Version 3

Safety Recall: 2018-20 Fit Audio Unit Software Update

Supersedes 23-005, dated February 3, 2023, to revise the information.

REVISION SUMMARY

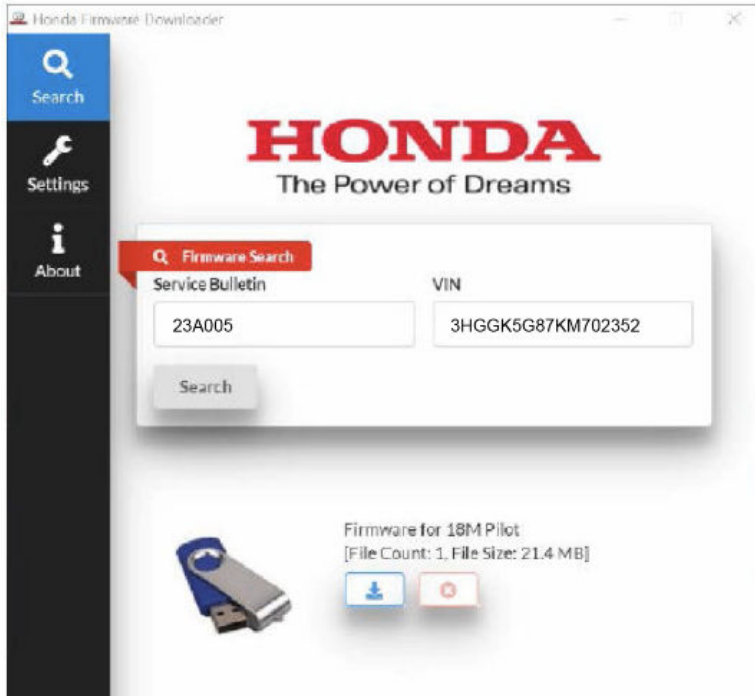
Under REPAIR PROCEDURE step 8, an image was updated.

8. In the space where it asks for the Service Bulletin, refer to the below table and enter the appropriate Honda Firmware Downloader Service Bulletin Number that is associated with the vehicle software version on the vehicle you are working on. Next, enter the vehicle's VIN.

9. Select the download icon.
